+158 Acre Parcel
168 Training Facility

LANDSCAPE PLAN

MVE PROJECT 61224
MVE DRAWING DEV-LS

EPC STORMWATER REVIEW COMMENTS
IN ORANGE BOXES WITH BLACK TEXT

SITE MAP
SCALE: 1"=100'

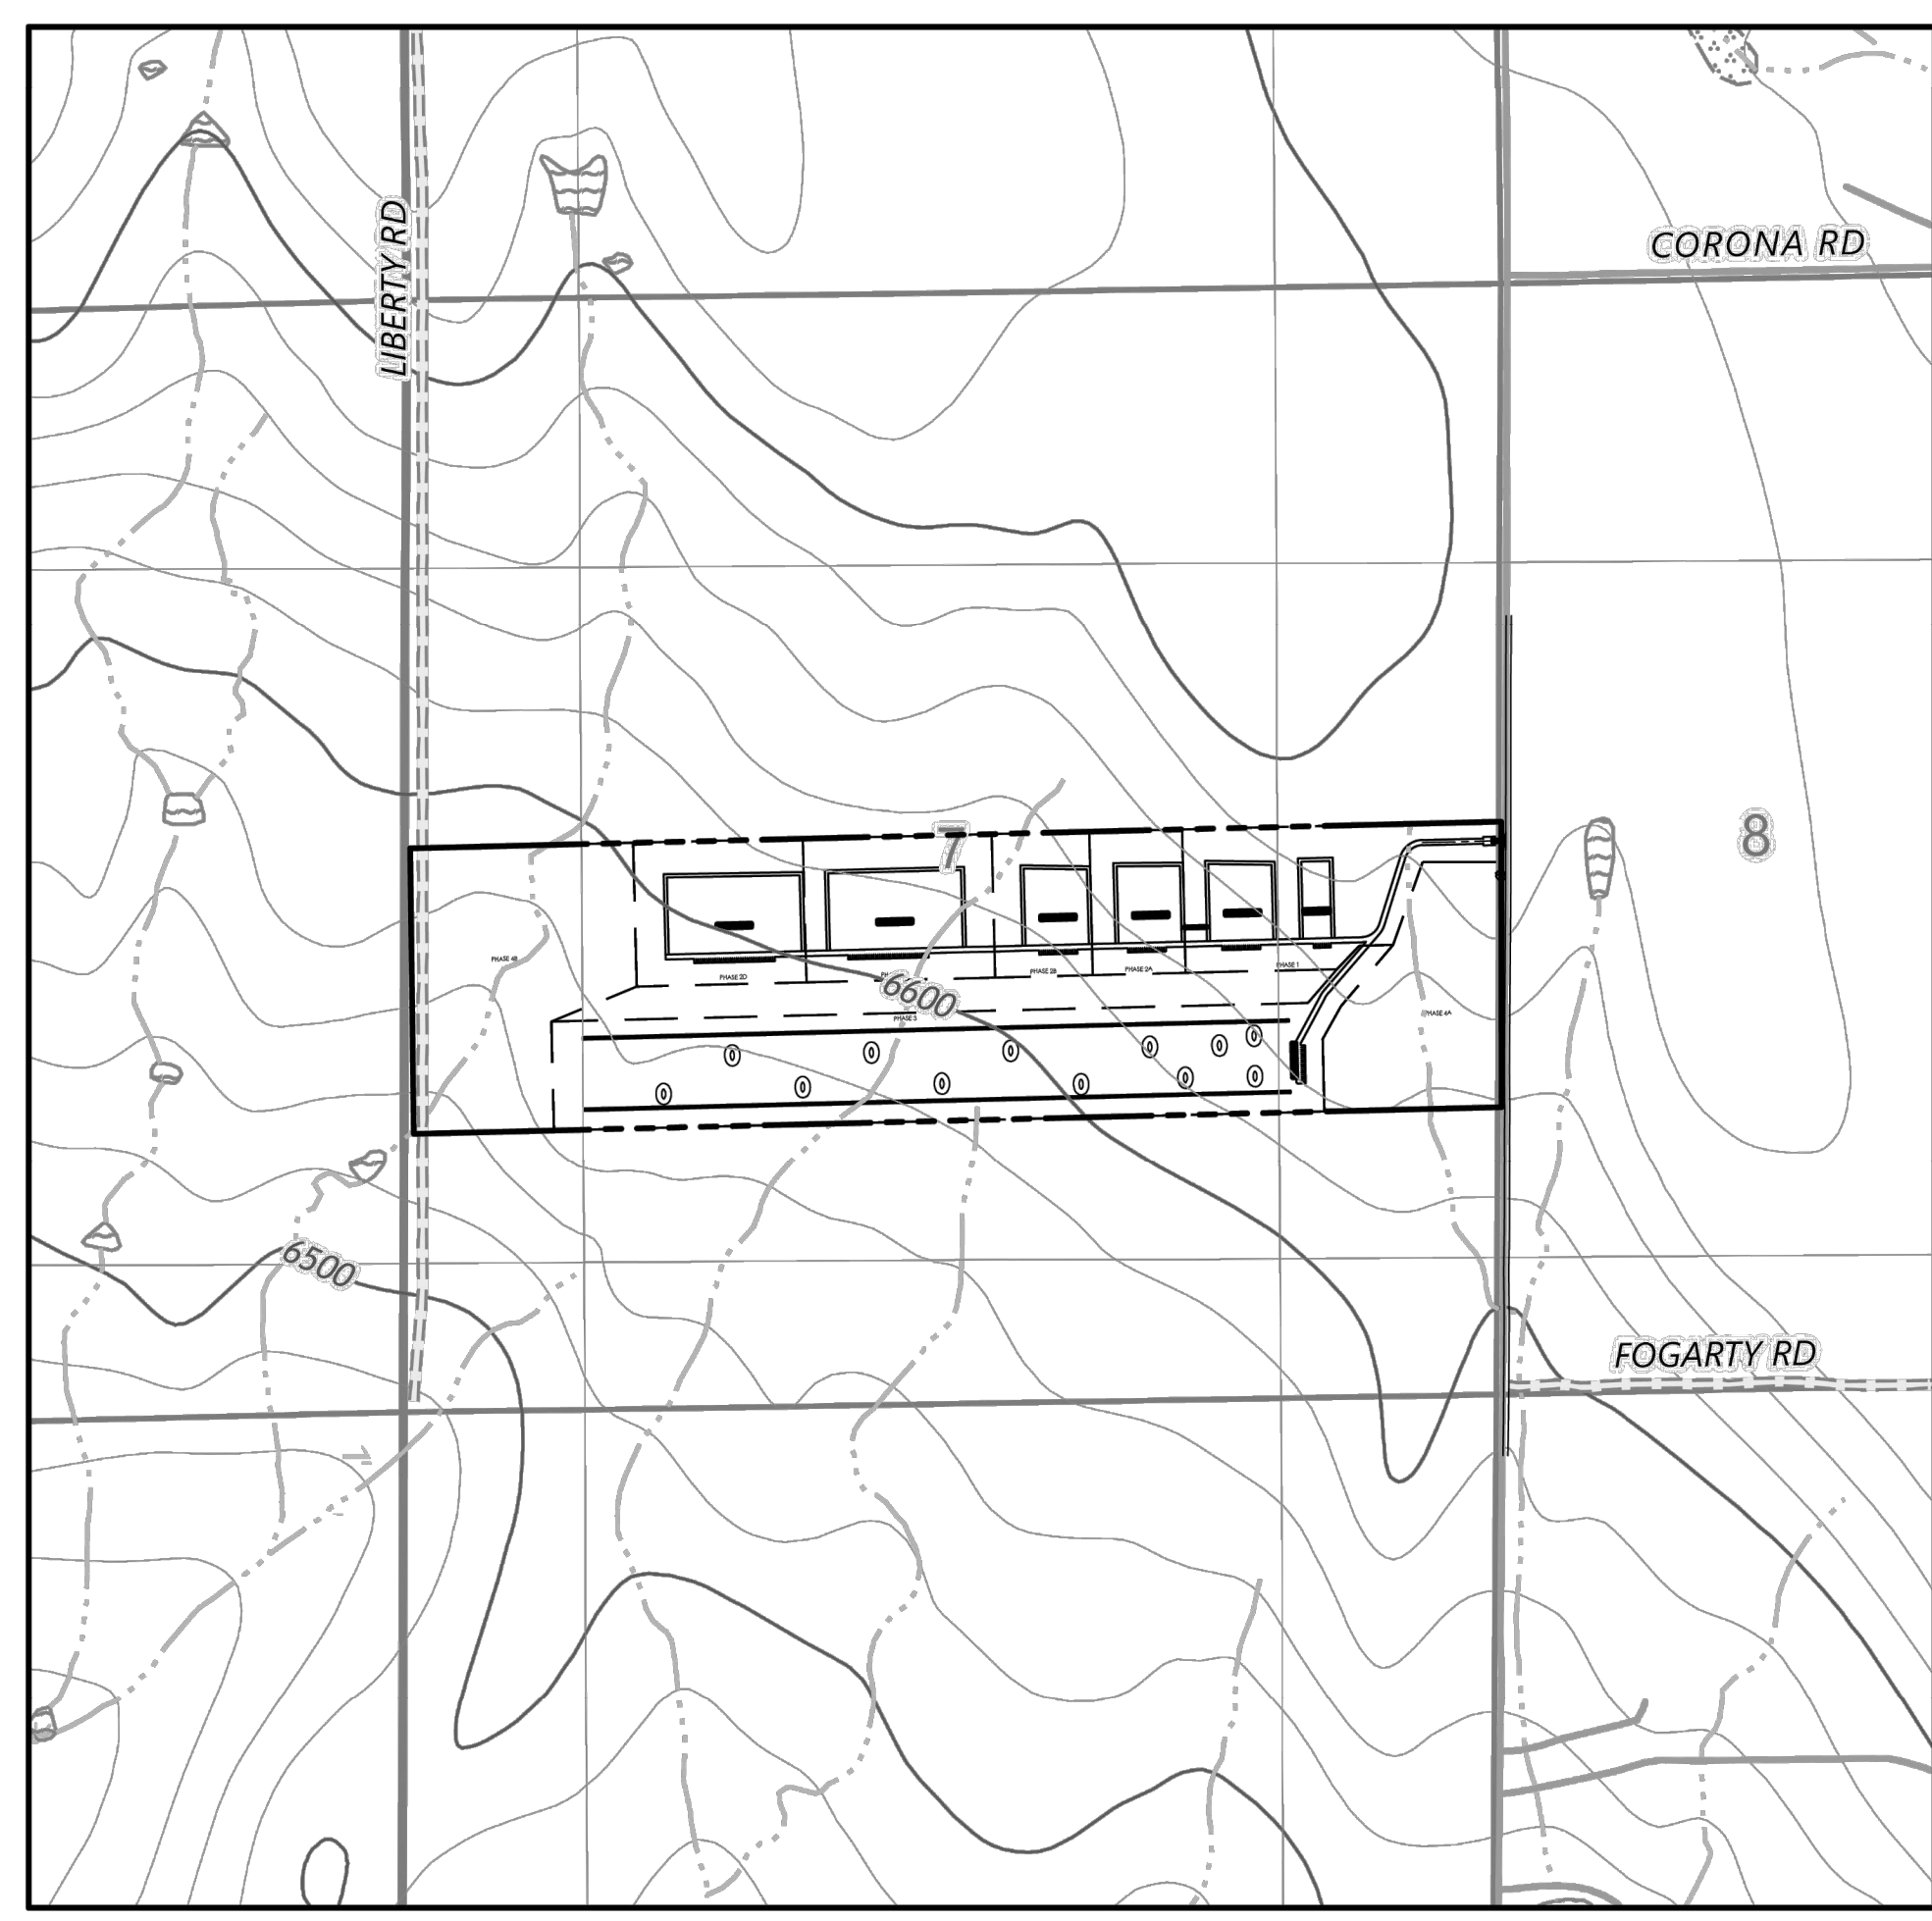
See Section 6.2.2.E. in the Land Development Code for details about Internal Landscaping requirements.

If you cannot meet this requirement please discuss the justification for your alternative plan in the Letter of Intent

Per Section 6.2.2.C.1. in the Land Development Code, a tree of a type suitable for parking lots shall be provided for every 15 parking spaces in parking lots with 15 or more parking spaces. The required trees may be clustered and shall be located in a manner which will divide and break up expanses of paving and long rows of parking and create a canopy effect over the parking lot.

If you cannot meet this requirement please discuss the justification for your alternative plan in the Letter of Intent

S. Calhan Hwy is a Minor Arterial Roadway which requires 1 tree per 25 feet and has a 20 foot depth of roadway landscaping area.

If you cannot meet this requirement please discuss the justification for your alternative plan in the Letter of Intent

3 Berm with Shrubs Detail
SCALE: NOT TO SCALE

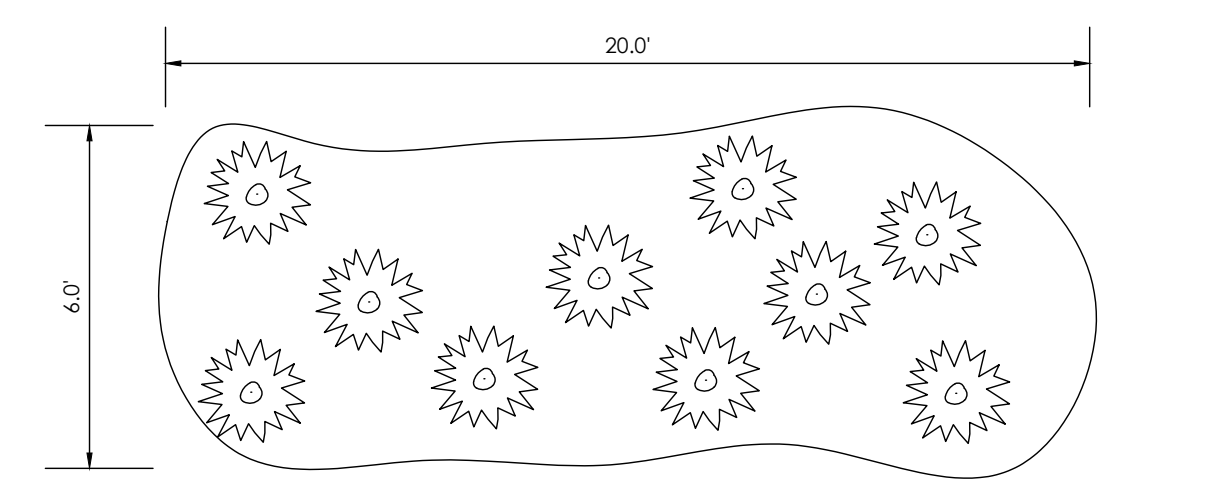
The GEC Plans reference seeding and mulching to be per the approved landscaping plans. I do not see seed mix and mulching specifications or limits on these plans. Please clearly delineate seeding and mulching limits so it is clear all areas will be stabilized.
